**LEE'S SUMMIT**  
MISSOURI  
Development Services Department

## Development Services Staff Report

<b>File Number</b>	PL2023-196
<b>File Name</b>	COMMERCIAL REZONING WITH PRELIMINARY DEVELOPMENT PLAN & CONCEPTUAL PLAN - Downtown Market Plaza
<b>Applicant</b>	Lane4 Property Group,
<b>Location</b>	201, 205, & 220 SE Green St.; 205 & 208 Johnson St.; & 200 & 202 SE 3rd St.
<b>Planning Commission Date</b>	September 26, 2023
<b>Heard by</b>	Planning Commission and City Council
<b>Analyst</b>	C. Shannon McGuire, Senior Planner

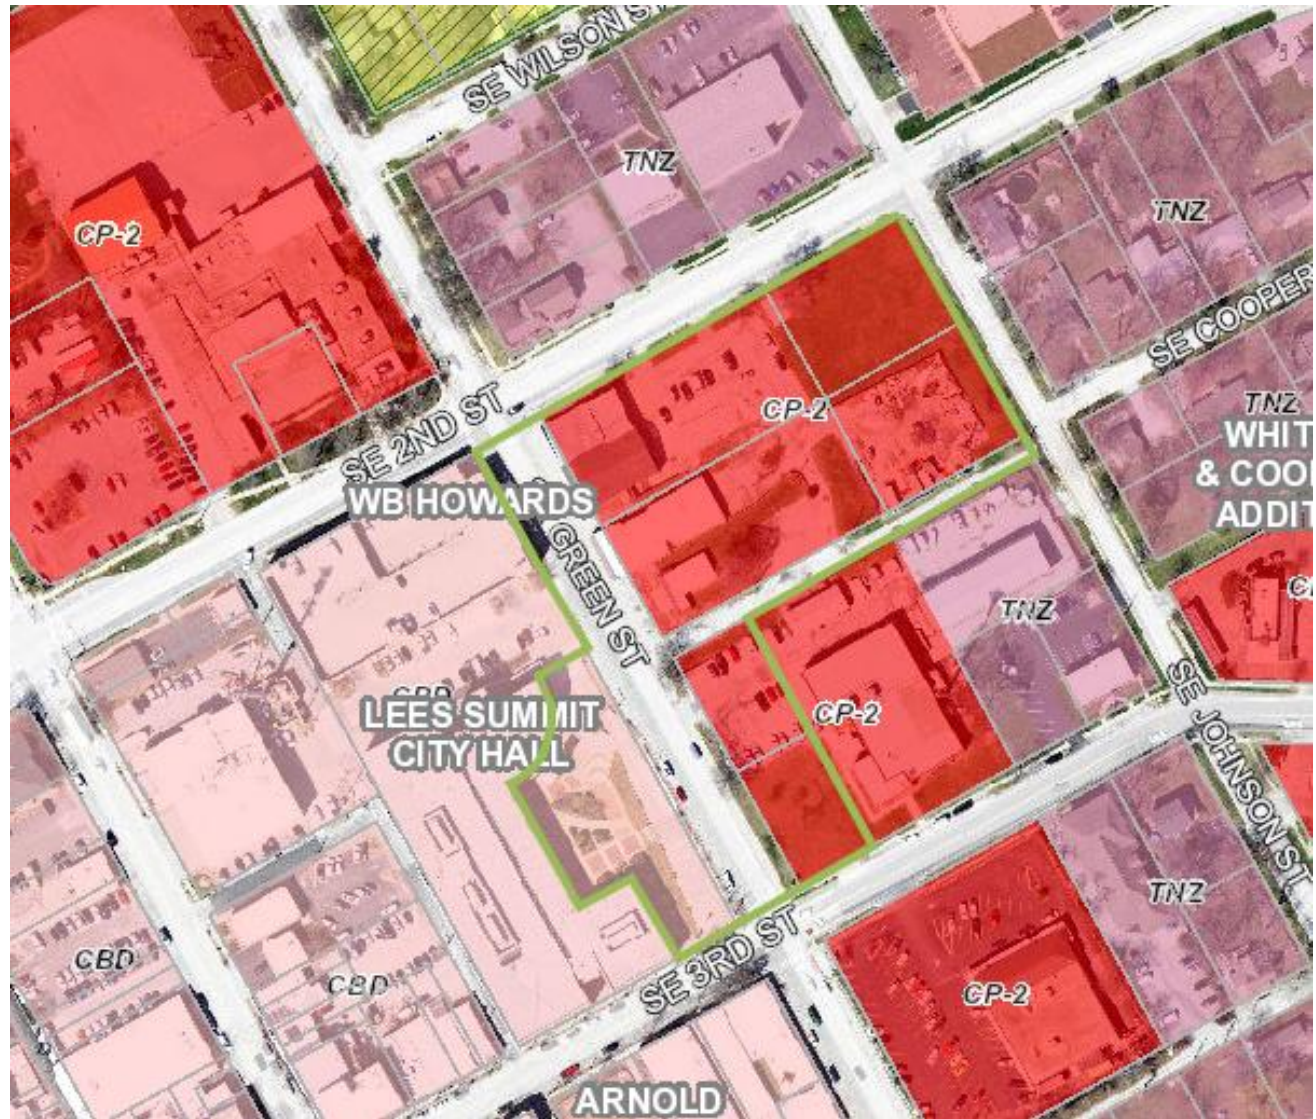
- Required – First and second floor elevations of street facing facades shall consist of brick.
- Proposed – Modify the Design Standards for the Downtown Core Area’s requirement that first and second floor elevations of street facing facades consist of brick, to allow for the façade on the second level to include the use of fiber cement panels, consistent with the elevations dated August 29, 2023.

- Recommendation – The applicant has stated in order to create a more dynamic façade, they included the use of fiber cement panels on the 2<sup>nd</sup> level of the proposed building. Additionally, the use of this material reduces the weight and structural load of the facade allowing for the design of the interior of the building to be more open and airier. The use of lap siding and cementitious wall panels is consistent to the style and materials used in the surrounding area. The requested modification is substantially similar to modifications granted to the Ellis Glen (PL2022-192) and DTLS Apartments (PL2018-234) developments. Staff finds the justifications to be reasonable and supports the requested modification.

1. A modification shall be granted to the Design Standards for the Downtown Core Area's requirement that first and second floor elevations of street facing facades consist of brick, to allow for the façade on the second level to include the use of use of fiber cement panels, consistent with the preliminary development plan date stamped August 29, 2023.
2. A modification of UDO Sec. 8.750, Acceptable plant materials, shall be granted to allow deciduous shade trees to be a minimum of 2.5" caliper at planting, evergreen trees to be a minimum height of 6' at planting and deciduous ornamental trees to be a minimum of 2" caliper at planting.
3. Development shall be in accordance with the preliminary development plan dated August 29, 2023, and the elevations dated August 29, 2023.
4. Development shall be in accordance with the Transportation Impact Analysis dated October 19, 2023.
